Facility: 6th & Cherry Parking Garage

Address: 555 E. Locust Street Date of Survey: 02/02/10 & 02/04/10

The 6th & Cherry parking structure was constructed in 1997. The structure has four parking levels, all of which are accessible via elevators at the SE and NE corners of the structure. This parking structure has a total of 379 parking spaces and therefore, per ADAAG 4.1.2 (5) a. – d., eight total accessible parking spaces are required.

CITY OF COLUMBIA
 6th & Cherry Parking Structure
 701 E. Broadway / Columbia, Missouri 65205
 GROUND FLOOR PLAN

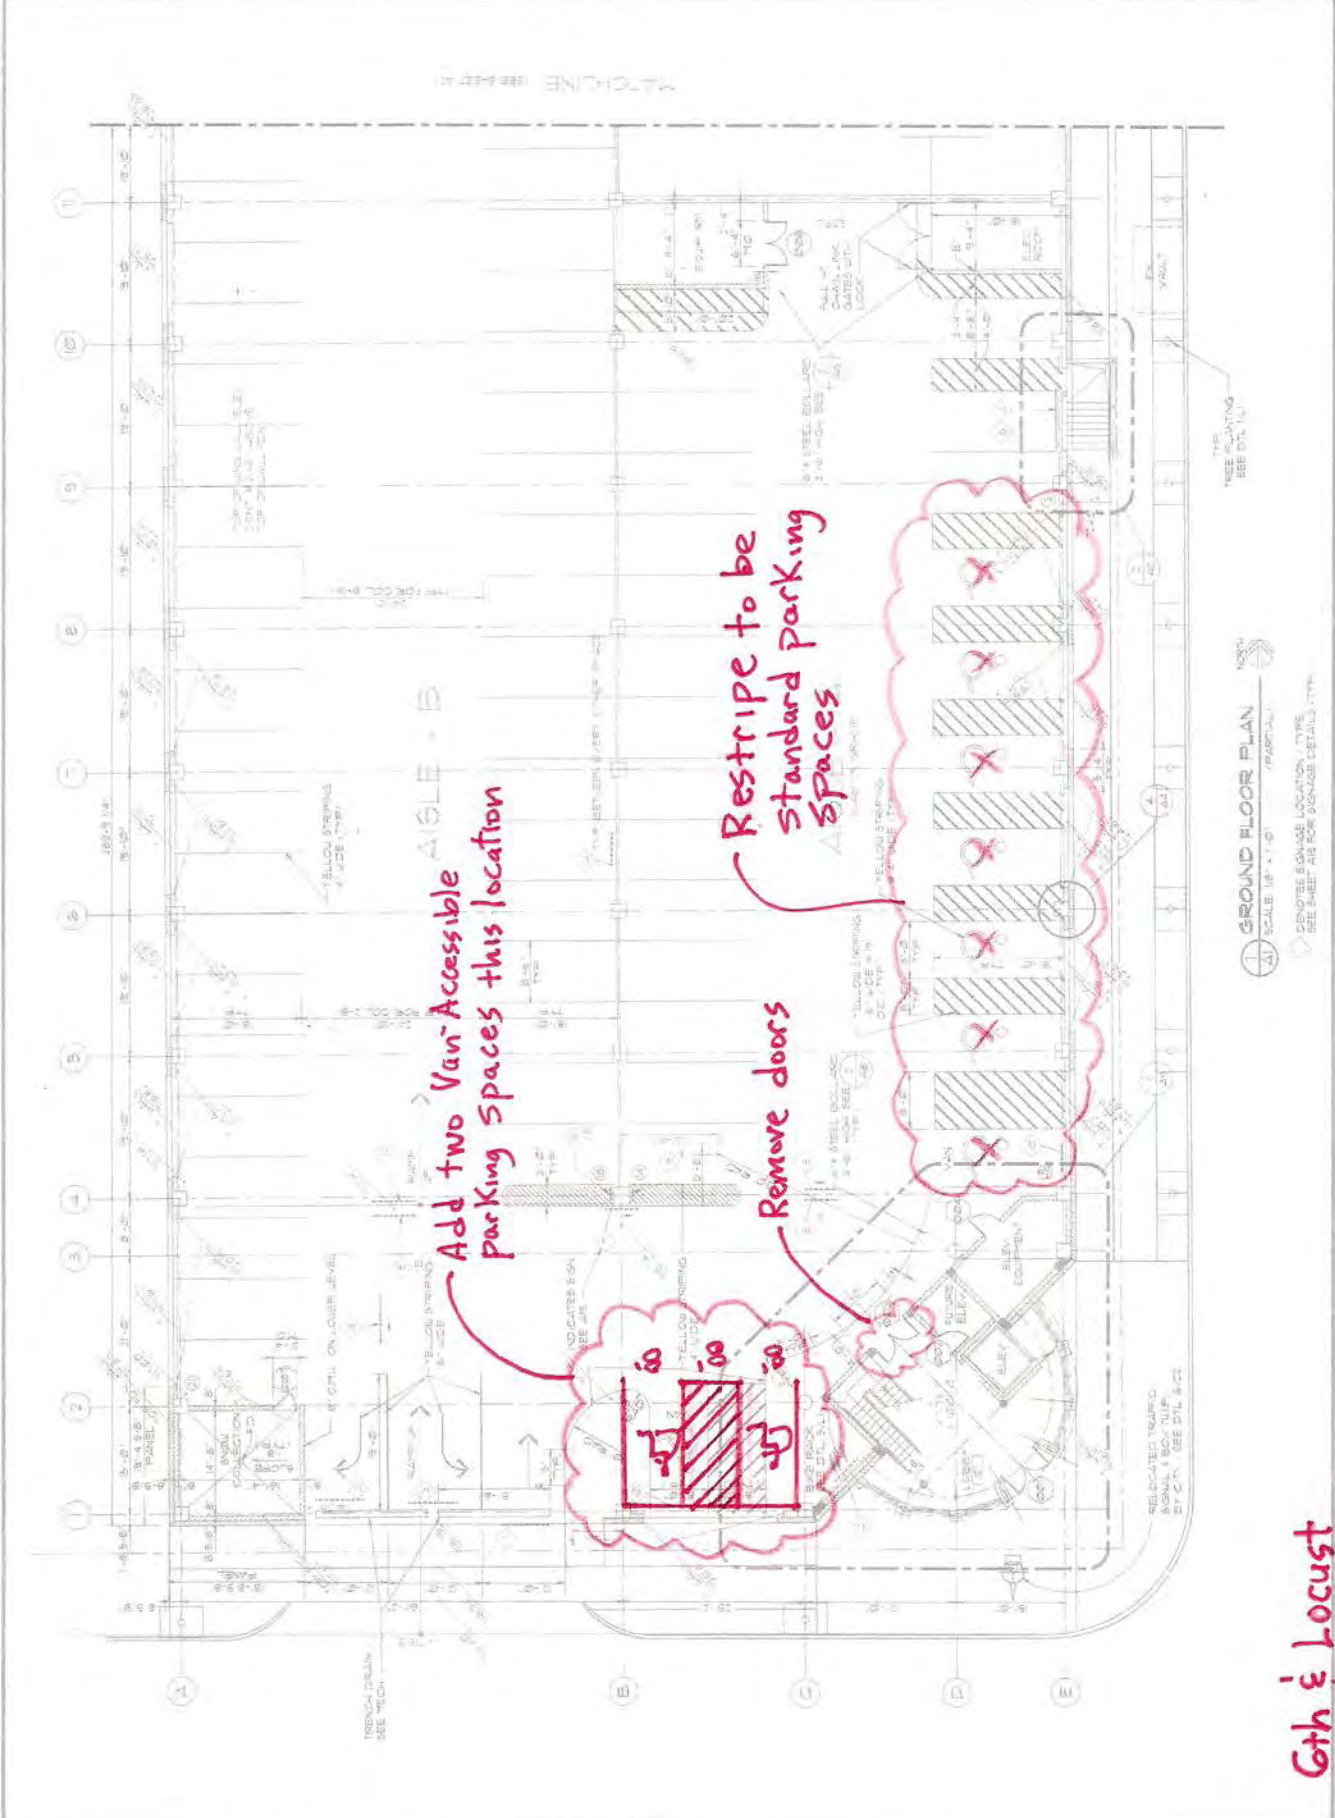
- Existing ADA parking spaces located on ground level along the east wall generally have slopes and cross-slopes that are close to the required 2% maximum slope in any direction, but most areas have at least minor issues with slope or cross-slopes up to 3.8%. The bigger issue is that the path to the interior lobby door from the parking spaces has slopes and cross-slopes up to 7.7% and the sidewalk at the exterior lobby doors slopes from the doors all the way down to the corner of 6th & Locust Street from 7% - 8.2%. Because the slopes at the exterior lobby doors at 6th & Cherry Street are mostly 2% or less, that entry/exit to the garage is considered to meet ADA requirements for door landing and access path and therefore, it is recommended that six standard ADA parking spaces be moved from the ground level up to the 2nd level as shown in the plans included with this report. Because the vertical clearance is too low at level 2 for van accessible spaces, I recommend creating two van access parking spaces on the ground level in location shown in plans included with this report. These changes will require re-stripping of spaces in the old locations and in new locations as well as moving the existing parking signs as required. **Estimated Cost: \$1,888.00**

- Because of the excessive slope at the exterior lobby doors located at the 6th & Locust pedestrian entrance, it is recommended that one of the doors be automated and infra-red no-touch sensors be used to control door operation so that it is more accessible to wheelchair users who do not have the ADA required level landing at the exterior area of the doors (creation of a level landing at the doors would affect the slopes of all the surrounding concrete sidewalk and appears to be infeasible at this location). **Estimated Cost: \$5,665.00**

- Remove pair of doors at 6th & Cherry interior lobby and at 6th & Locust interior lobby to allow for better wheelchair access as the slabs at those interior doors are not level as required for door entry areas per ADAAG.
